ENCLOSURE 5 TO NL-09-036

Applied Science Associates, Inc. Report dated March 16, 2009,
"Review of Thermal Discharge Issues to the Hudson River in NRC Draft
SEIS for Indian Point 2 and 3"

ENTERGY NUCLEAR OPERATIONS, INC
INDIAN POINT NUCLEAR GENERATING UNIT NOS. 2 and 3
DOCKETS 50-247 and 50-286

**Review of Thermal Discharge Issues to the Hudson
River in NRC Draft SEIS for Indian Point 2 and 3**

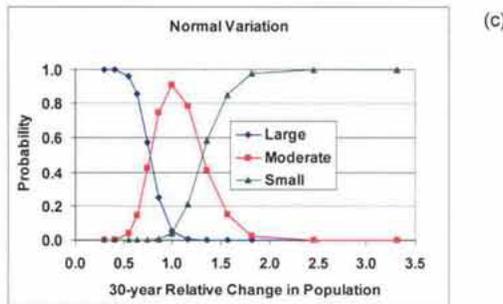
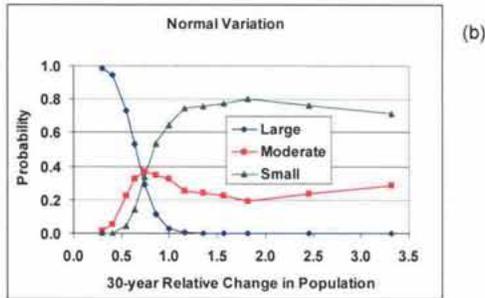
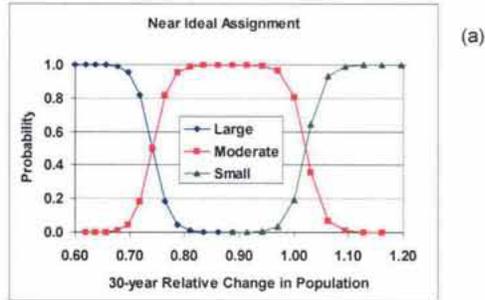
Classification probabilities for an "ideal" procedure are illustrated in figure 1a, and the probabilities calculated for NRC's classification procedure are illustrated in figure 1b. In Figure 1a, the ranges of population change over which more than one classification is possible are small (~0.65 to ~0.85 and ~0.95 to ~1.1), and there are no rates of population change for which more than two classifications are possible. As shown in Figure 1b, probabilities of misclassification are high using NRC's procedure. There is a 20%-40% chance that a trend will be classified as Moderate for population

To illustrate the potential for improvement of the classification process, a simpler set of rules was applied to the simulated data (Appendix A). This scheme produced Large, Moderate, and Small classifications that were much more distinct than those produced by NRC's rules (Figure 1c). Separation of the Large and Small categories was nearly complete, and a Moderate category centered on relative change = 1, where the probability of Large and Small was very low. The zones of overlap of two categories, either Large with Moderate or Moderate with Small, are much smaller than with the classification rules used by NRC. This alternate classification is still conservative, because population that are growing, but at a relatively low rate (up to about a 120% increase over 30 years) have a higher probability of being incorrectly classified as Moderate than of being correctly classified as Small.

Figure B-3 Classification under NRC decision rules of simulated population abundance data with normal variation around the expected value, $\delta = 0.25$. Probabilities for the three classifications always sum to unity.

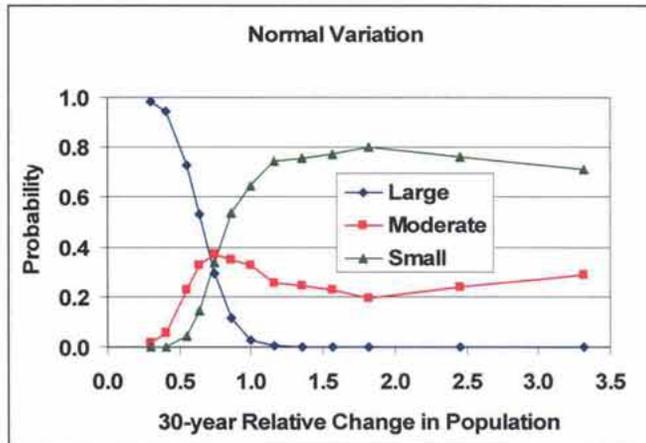
The NRC process, for a population with normal variation in annual abundance and $\delta = 0.25$, departs substantially from the ideal (Figure B-3). The delineation between the Large and Small categories of potential impact was relatively distinct, with overlap of the categories occurring only in the range of 0.5 to 1.0 relative change in population size. However, the probability that a population could be classified as Moderate potential impact was between 0.2 and 0.4 for population change ranging from 0.5 to 3.3, i.e. a population that had declined to 50% of its original abundance and a population that had grown to more than 3 times its original abundance have essentially the same probability of being classified as Moderate potential impact. The probability that a population would be classified as having a Large potential impact was also non-trivial for populations that had declined relatively little: 0.32 for a trend resulting in 0.7 of initial abundance, 0.12 for a trend resulting in 0.9 of initial abundance, and 0.03 for a population with unchanged abundance. The 0.6 to 0.9 range in population change is a zone in which discrimination is highly uncertain as the probabilities of the Large potential impact category range from 0.53 to 0.11; probabilities of the Moderate category range from 0.33 to 0.37; and probabilities of the Small category range from 0.14 to 0.65.

Figure B-4 Classification under NRC decision rules of simulated population abundance data with log-normal variation around the expected value, $\delta = 0.25$. Probabilities for the three classifications always sum to unity.

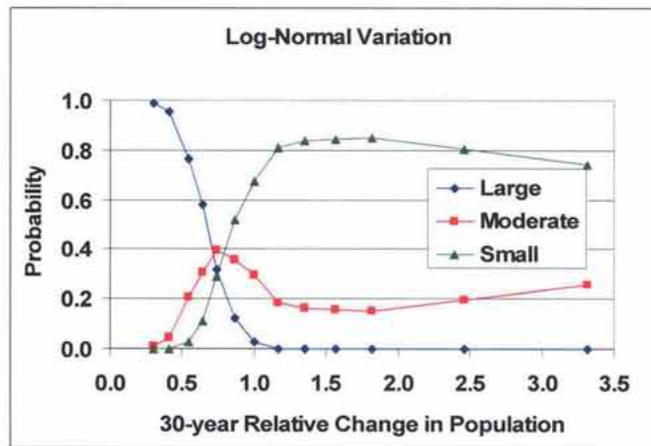
If population variation is lognormal rather than normal, the operating characteristics of the NRC classification are essentially the same (Figure B-4), although

between relative population change from about 1.2 to 2.5 the probability of a population being classified as Moderate impact declines slightly below 0.2.

Figure B-7 Classification of simulated population abundance data with normal variation around the expected value, $\delta = 0.25$, under rules based on significant positive or negative slopes, each considered significant if $p < 0.10$. Probabilities for the three classifications always sum to unity.

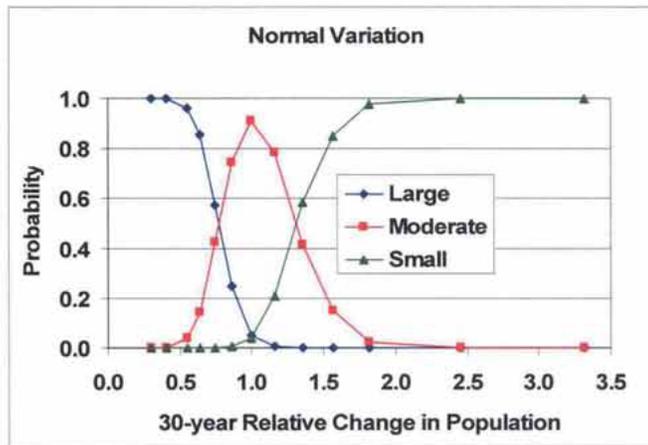
This rule resulted in nearly complete separation of the Large and Small categories, and a Moderate category centered on relative change = 1, where the probability of Large and Small was very low (Figure B-7). The zones of overlap of two categories, either Large with Moderate or Moderate with Small, are much smaller than with the classification rules used by NRC. This classification scheme may or may not be preferable for NRC's purpose, but it illustrates that different sets of rules can produce very different classifications for the same data, and that no classification scheme should be used without first testing its performance on data with known characteristics.
